Subject: INFILTRATION FEASIBILITY CONDITION LETTER  
PACIFIC BEACH HOTEL  
4545 MISSION BAY DRIVE  
SAN DIEGO, CALIFORNIA

Subject: RESPONSE TO CITY COMMENTS  
PACIFIC BEACH HOTEL  
4545 MISSION BAY DRIVE  
SAN DIEGO, CALIFORNIA

- References:
1. *Preliminary Geotechnical Investigation, Pacific Beach Hotel, 4545 Mission Bay Drive, San Diego, California*, prepared by Geocon Incorporated, dated November 21, 2024 (Project No. G3422-52-01).
  2. *Infiltration Feasibility Condition Letter, Pacific Beach Hotel, 4545 Mission Bay Drive, San Diego, California*, prepared by Geocon Incorporated, dated March 27, 2025 (Project No. G3422-52-01).
  3. *Shoring and Improvement Plans for: Pacific Beach Hotel, Between Garnet Avenue and Bunker Hill Street, San Diego, California*, prepared by KPFF, undated.
  4. *Project Issues Report (Discretionary Project), 4545 Mission Bay Drive*, prepared by City of San Diego, dated March 18, 2025 (Project No. PRJ-1129794).

STORMWATER MAP DATE 03 - 26 - 2025  
FIGURE 1

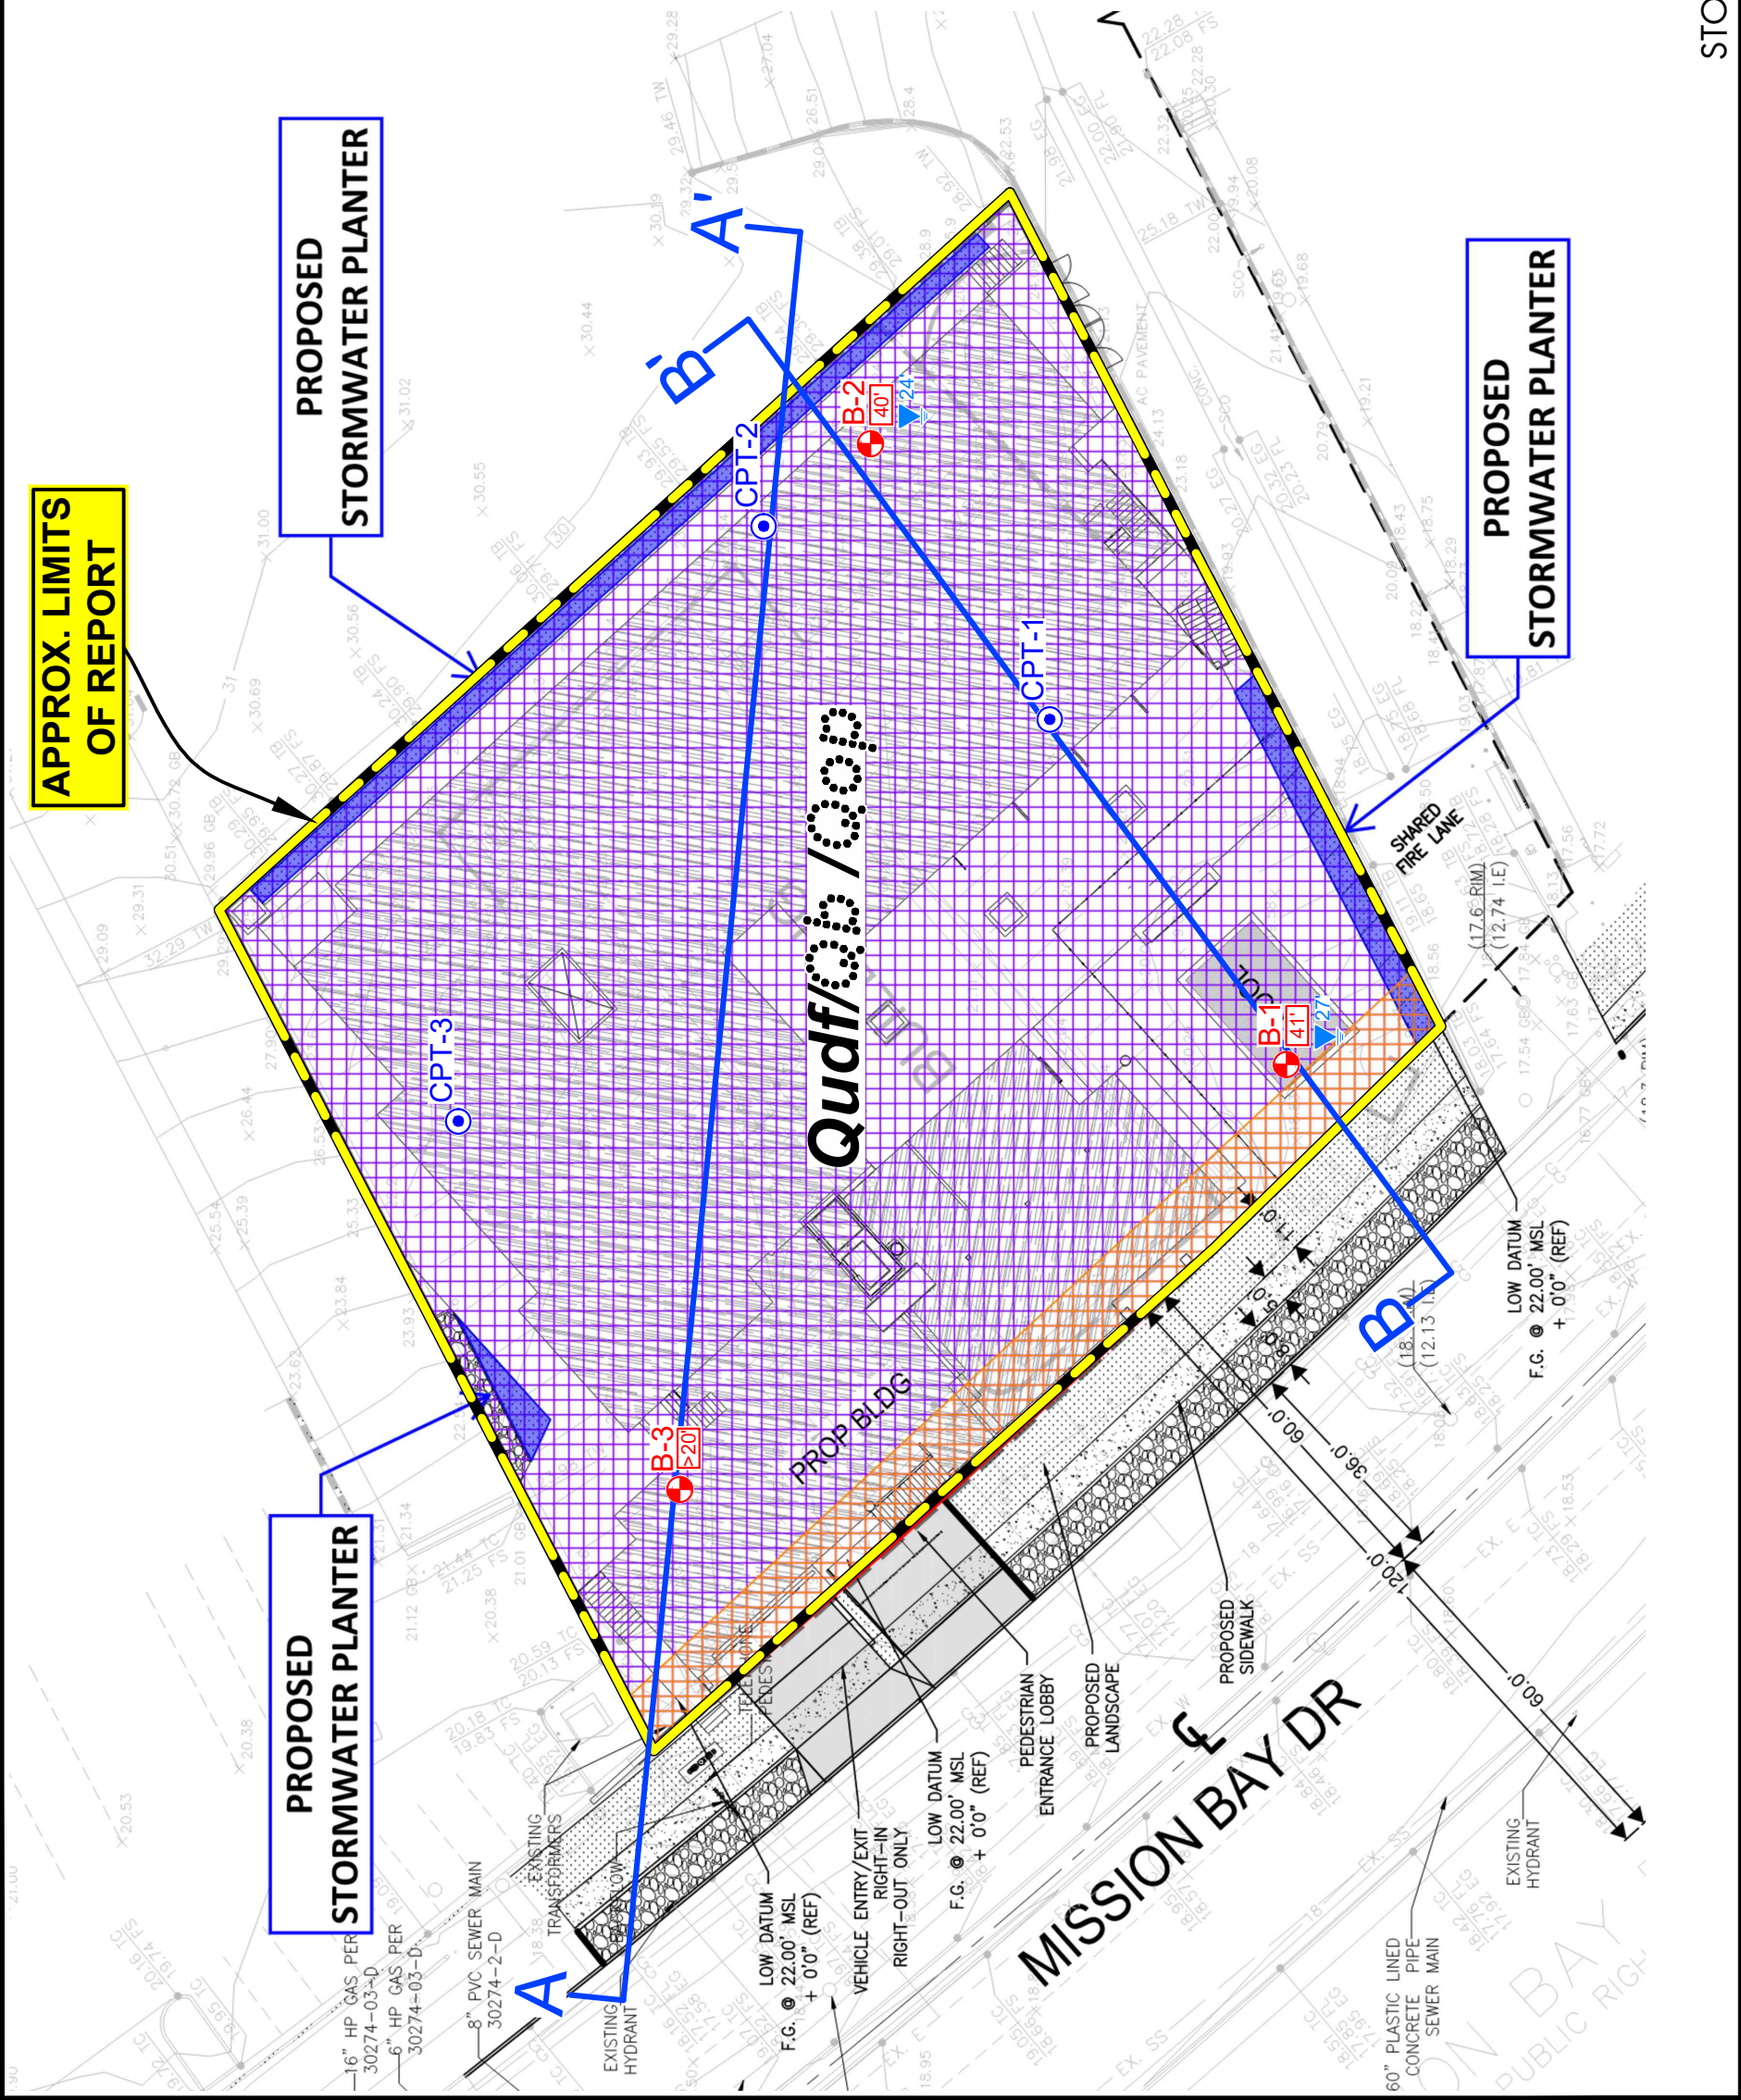
**An Exhibit for all applicable DMA’s that clearly labels:**

- **Proposed development areas and development type.**
- **All applicable features and setbacks that prevent partial or full infiltration, including underground utilities, structures, retaining walls, fill slopes, natural slopes, and existing fill materials greater than 5 feet.**
- **Potential locations for structural BMPs.**
- **Areas where full/partial infiltration BMPs cannot be proposed.**

We opine infiltration at the site is not feasible from a geotechnical engineering standpoint due to the presence of 5 feet or greater of fill across the site. Therefore, we opine the site (all DMAs) is not feasible

The Stormwater Map, Figure 1, presents the grading plan as a base map. The figure shows the development area and proposed buildings and improvements. The setbacks are shown on the map that illustrate our opinion that the entire project site is infeasible for infiltration.
